# **SECTION 42A REPORT**

Report on submissions and further submissions

**Topic: Transport**

**Dated: 21 October 2024**

**Figure – TRAN 3 - approach sightlines**

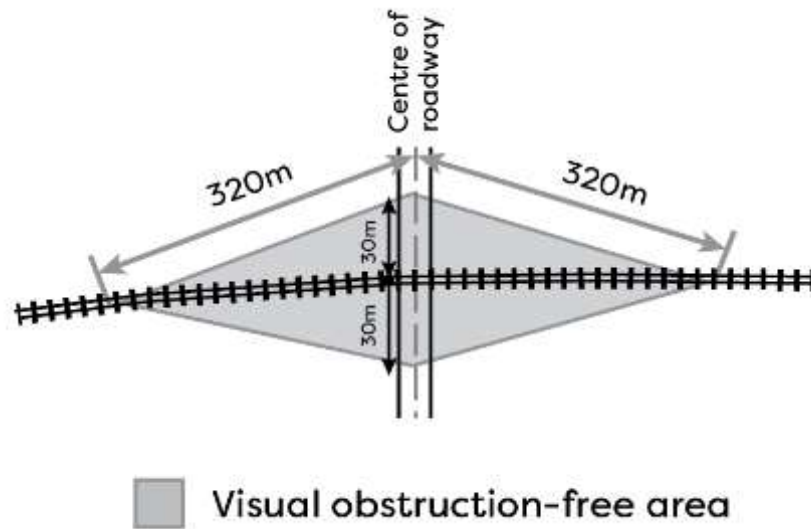
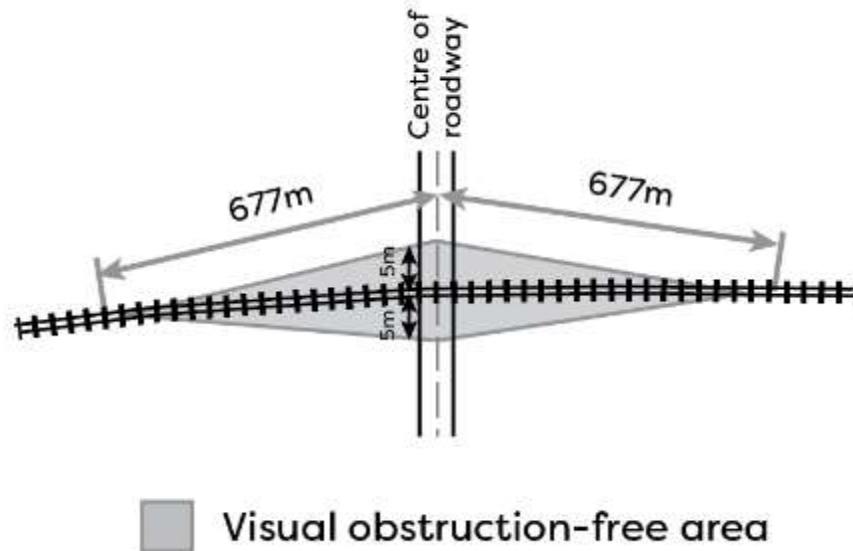
121. TRAN-R14 contains the standards for the minimum distance from a vehicle access to a railway level crossing, and the sightlines for railway level crossings to ensure visibility for safe crossings. KiwiRail [51.34] sought to rename the standard to assist with the clear interpretation and implementation to be "Rail vehicle crossing setbacks and sightlines". This does not quite describe what the standard does, and I suggest this be reworded to "Setbacks and sightlines near level railway crossings". The change is a clearer description of what the standard does.

2. For railway level crossings controlled by ~~stop signs or~~ give way signs, any structures, vegetation or other visual obstructions must not be located within the approach sightlines or restart sightline areas as shown in the shaded areas of Figure - TRAN 3 and Figure - TRAN 4.
